SUBJECT: Redline Pages to the Periodic Report 5 for the Upper Three Runs Integrator Operable Unit (IOU) (U) (SRNS-RP-2017-00548, Revision 1, July 2018) and Savannah River Site's Responses to Regulatory Comments on the Revision 0 Document, CERCLIS Number: 70

**Final SRS Responses to EPA Comments on
Periodic Report 5 for the Upper Three Runs IOU,
SRNS-RP-2017-00548, Revision 0, February 2018, CERCLIS Number: 70
Page 1 of 9**

Final SRS Responses to South Carolina
Department of Health and Environmental Control Comments on:
Periodic Report 5 for the Upper Three Runs Integrator Operable Unit (IOU) (U),
CERCLIS Number: 70 (SRNS-RP-2017-00548, Revision 0, February 2018)
Page 1 of 3

Figure 1-4d: Operable Units and Topography Associated with the UTR IOU - R Area and G Area Unit ATTA

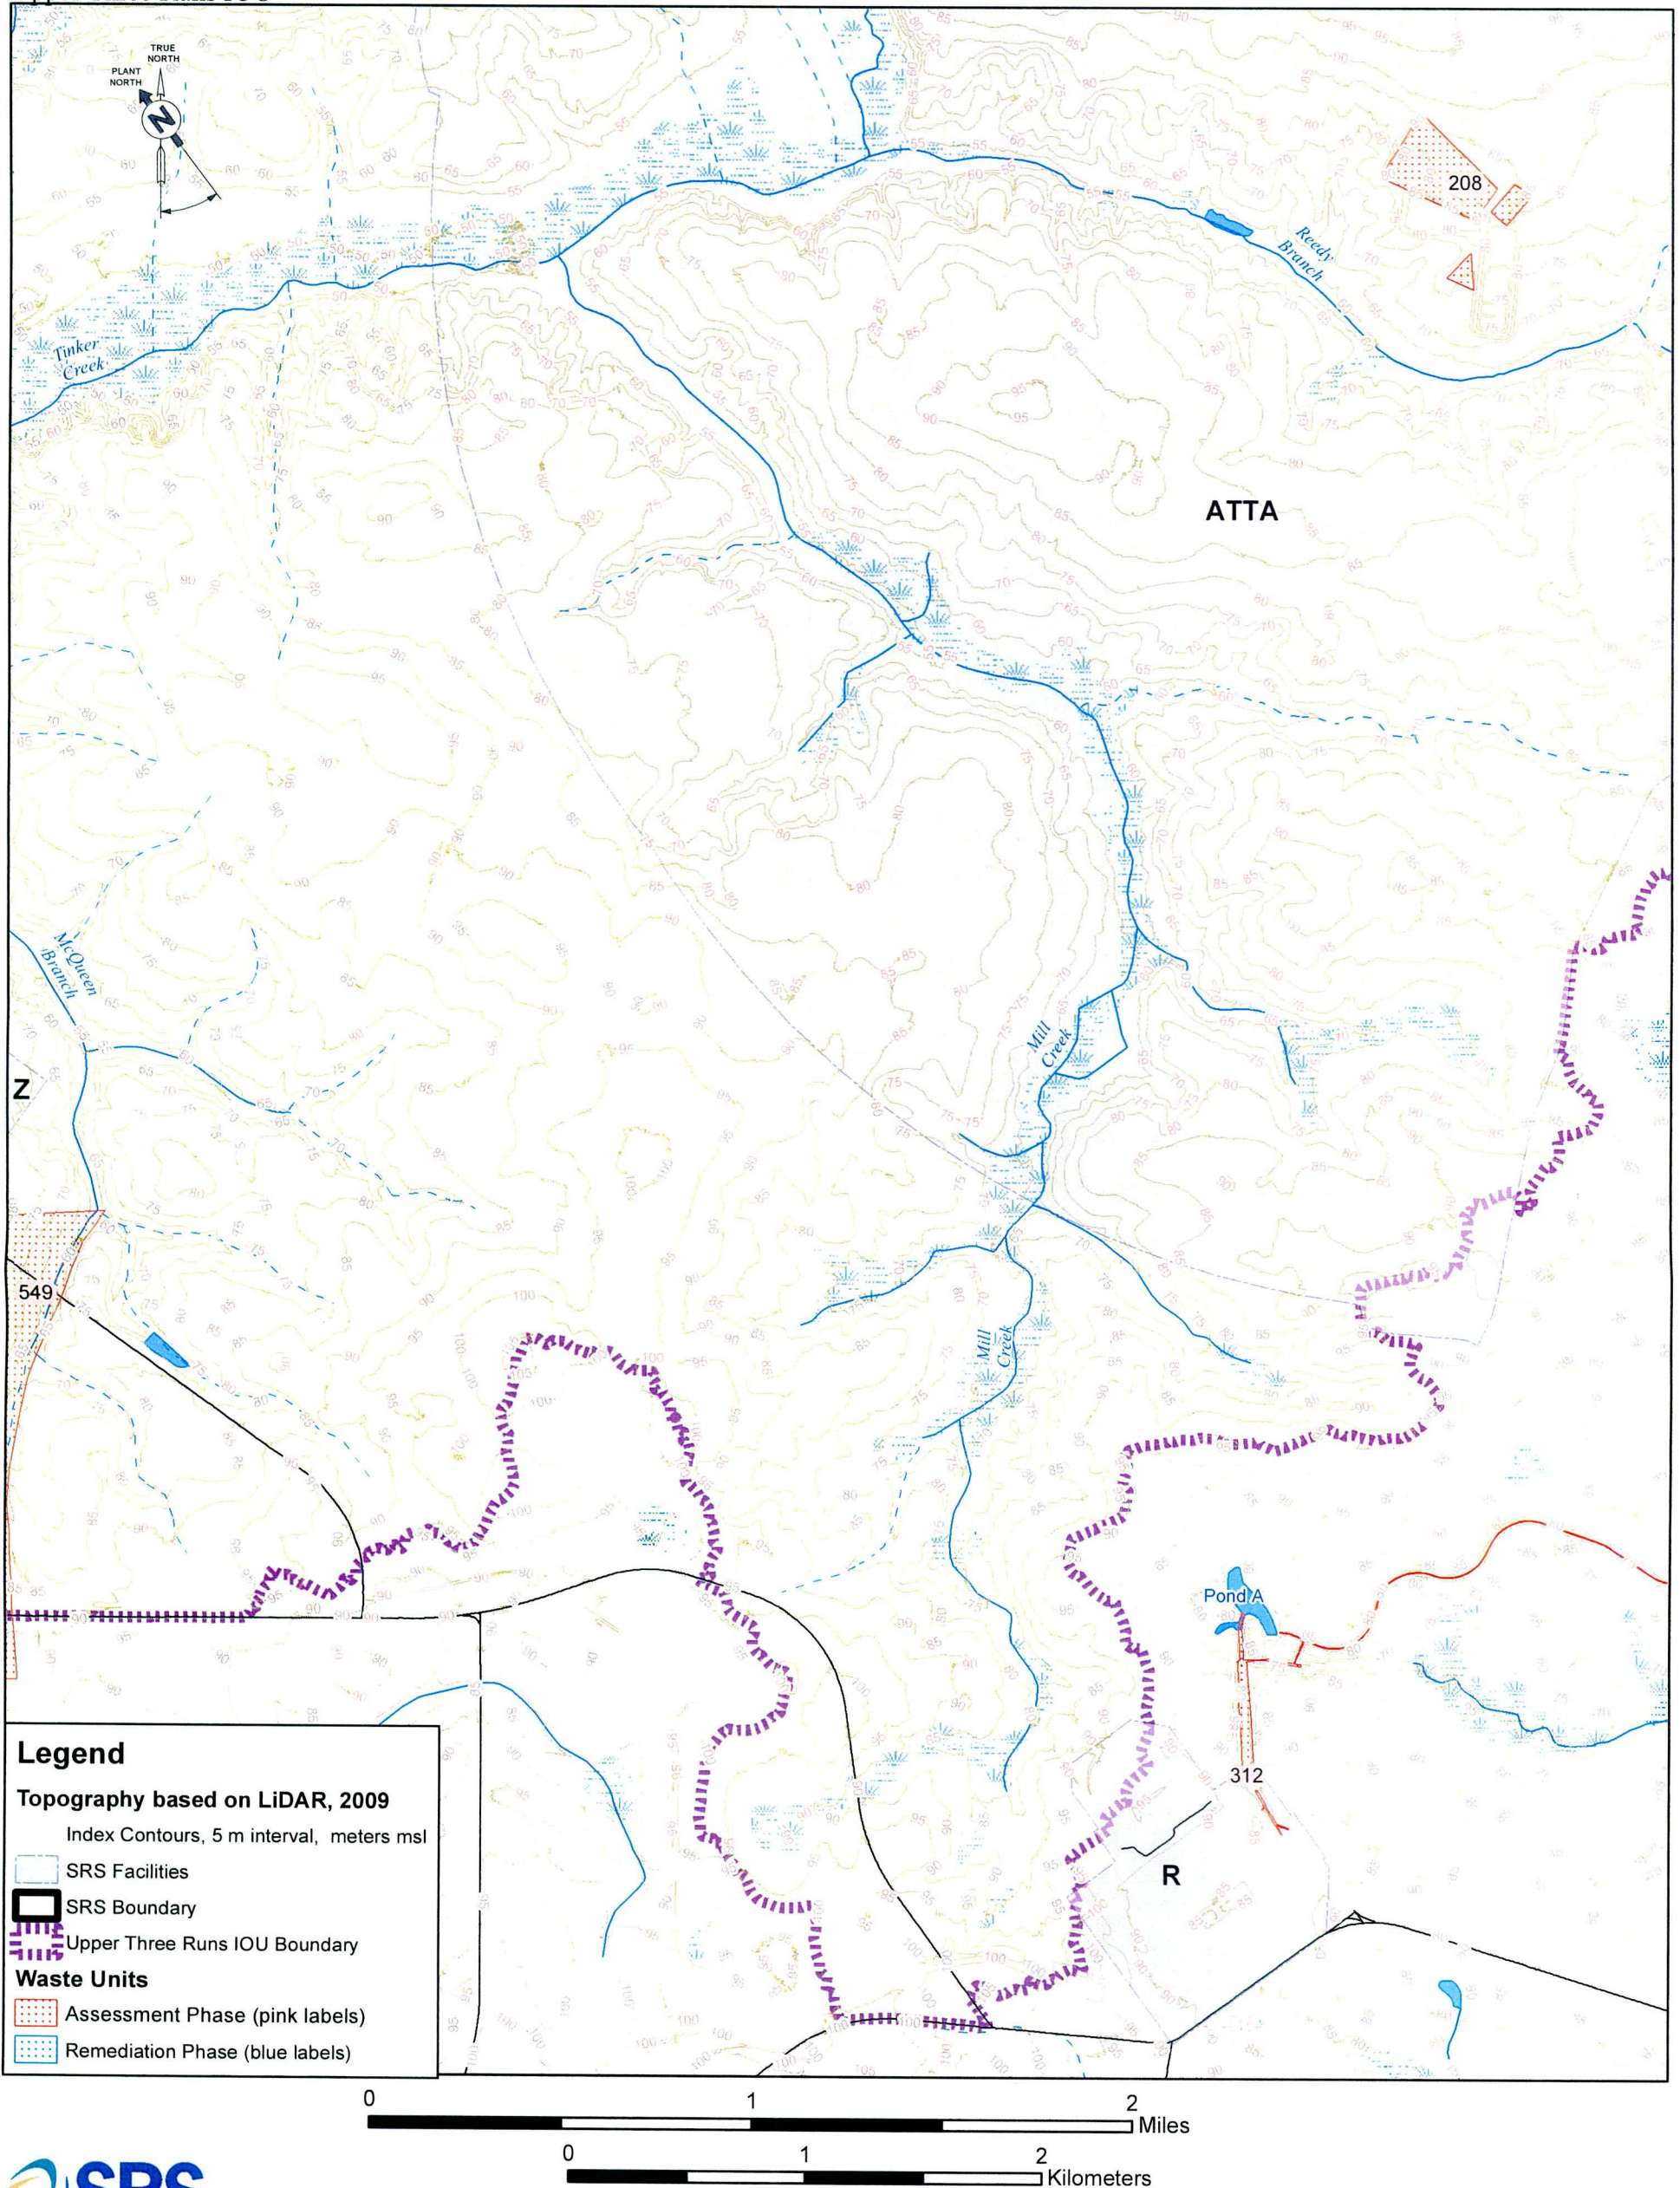
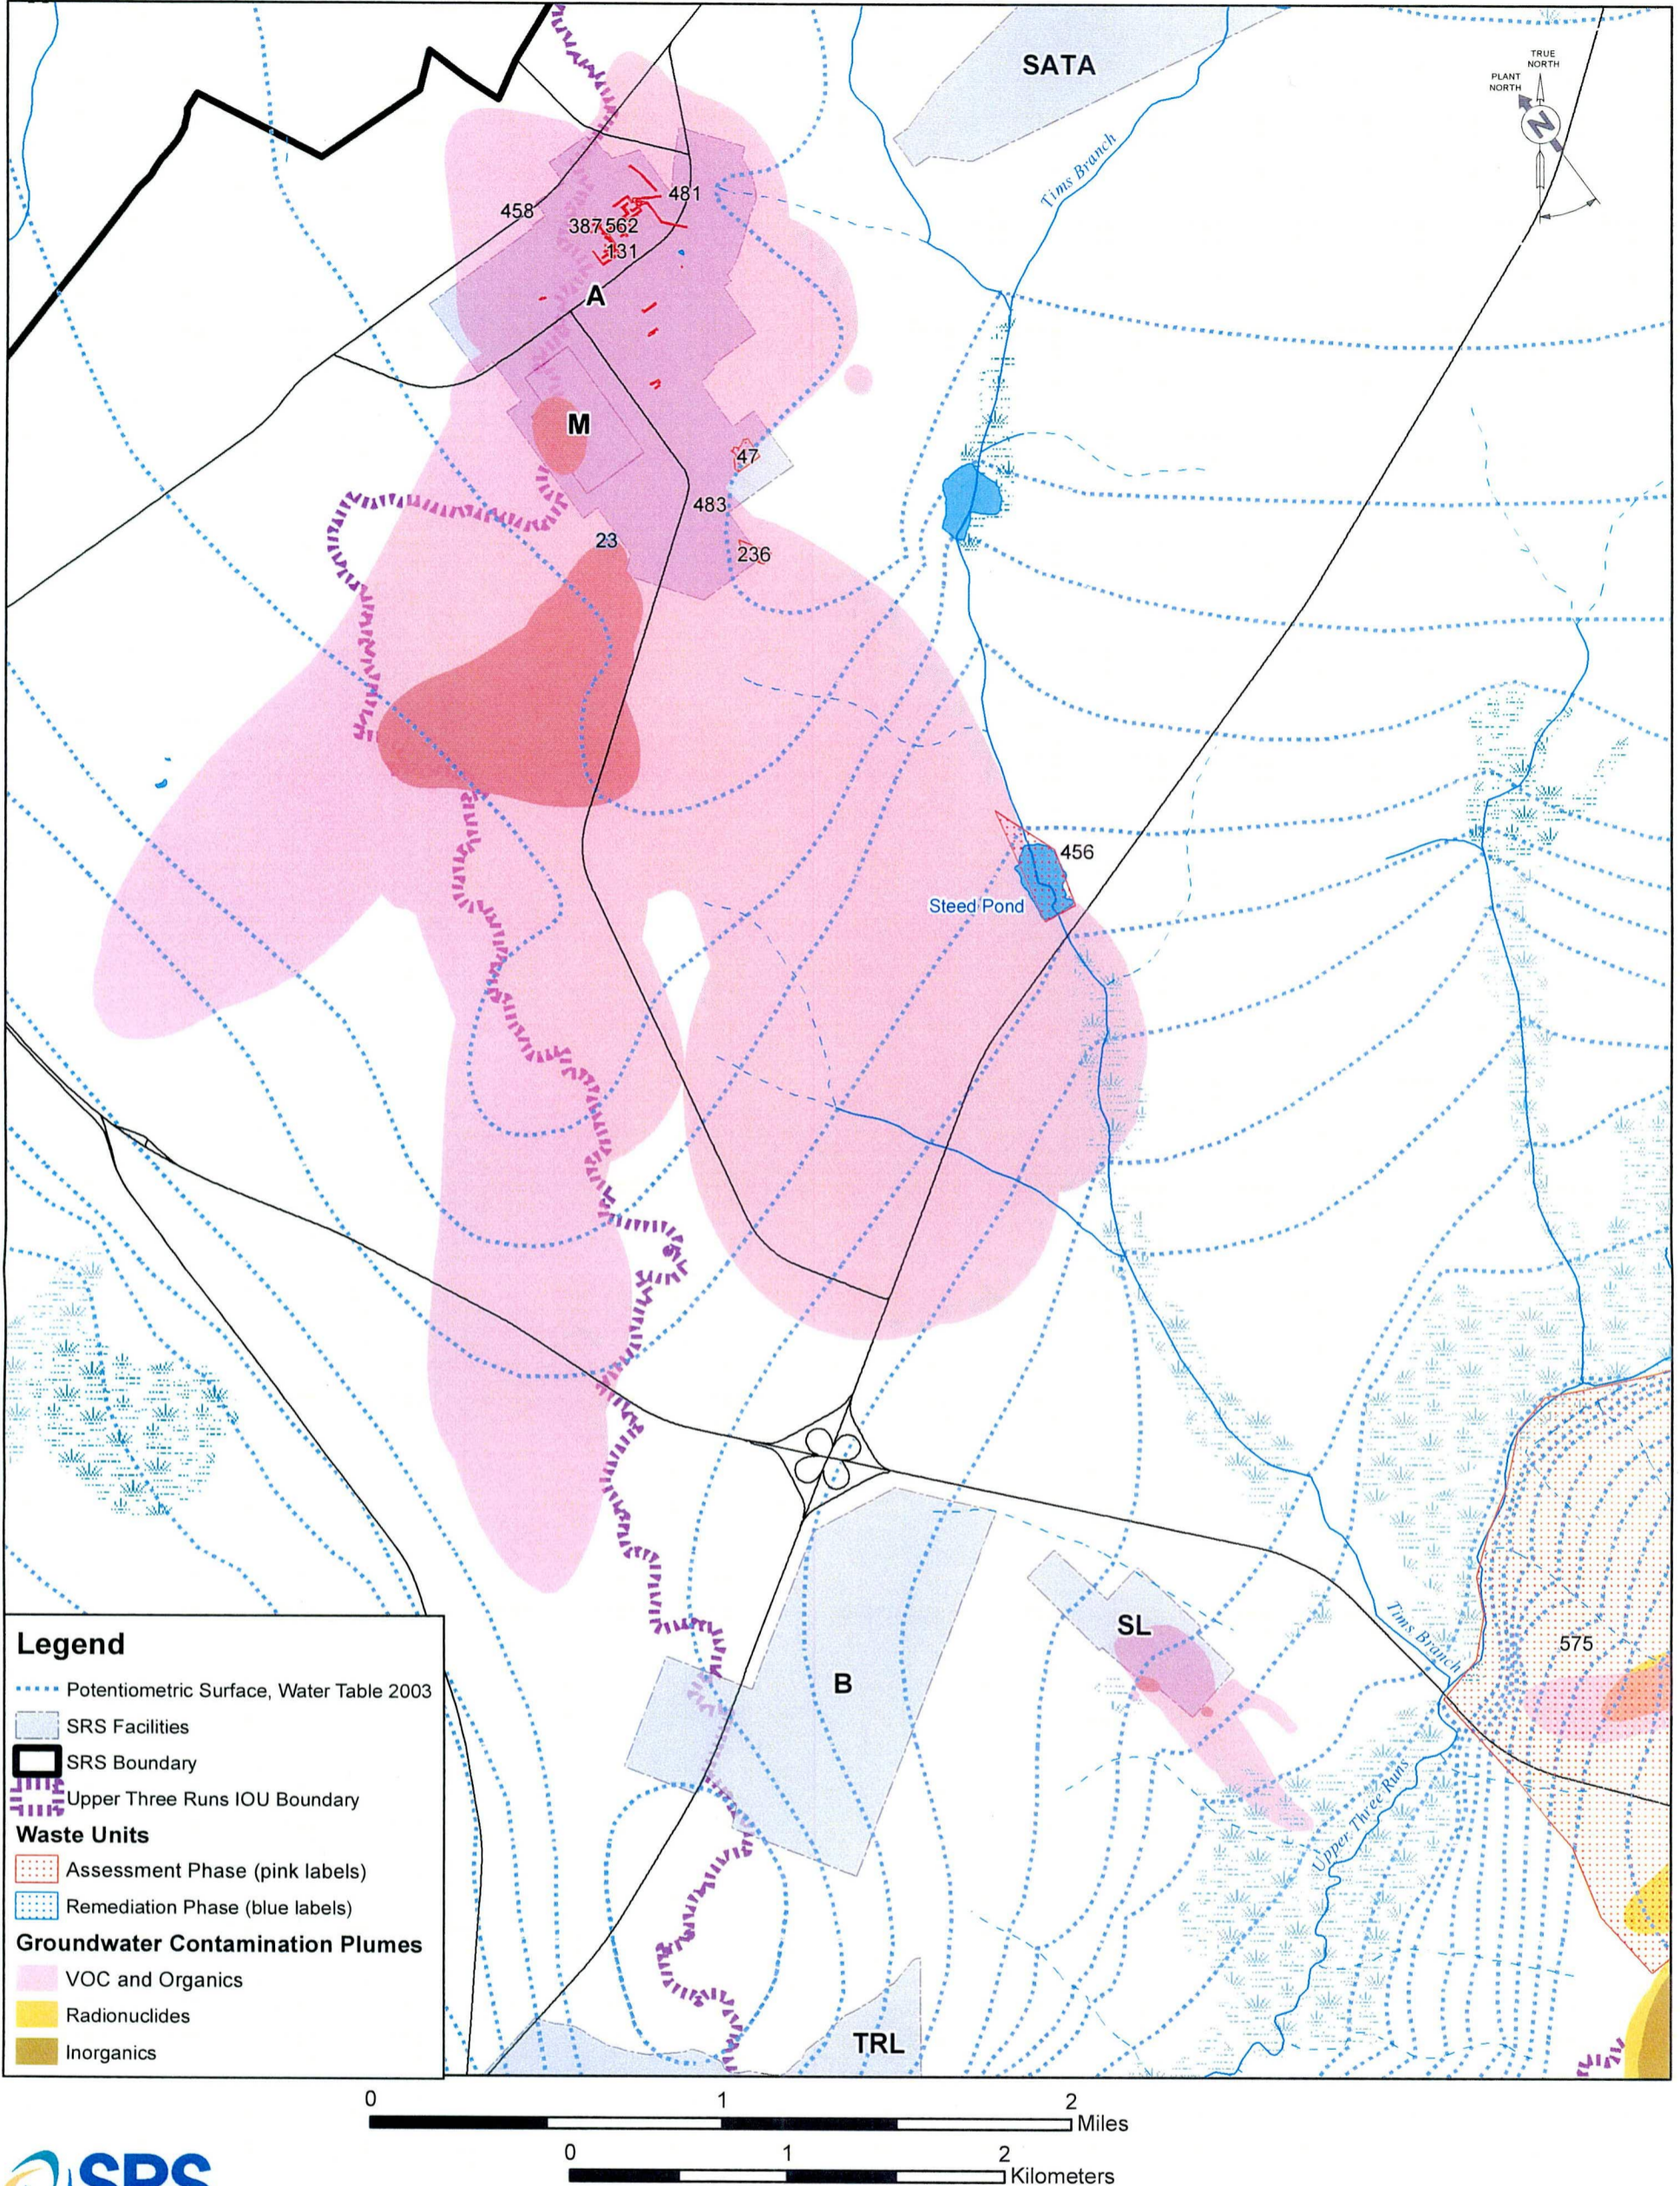
1. Figure 1-4a through Figure 1-4f, pages 1-23 through 1-33. Figures 1-4a through 1-4f should be labeled “Operable Units, Potentiometric Contours, and Groundwater Plumes Associated with the UTR IOU” for each unit area as stated on pages 1-23 through 1-33. Also, in the revision of PR5, please delete the additional copy of Figure 1-4c and insert Figure 1-4d.

Response: Agree. The new Figures 1-4a to 1-4d represent “Operable Units and Topography Associated with the UTR IOU”, and the new Figures 1-5a to 1-5d are “Operable Units, Potentiometric Contours and Groundwater Plumes Associated with the UTR IOU” and labeled appropriately.
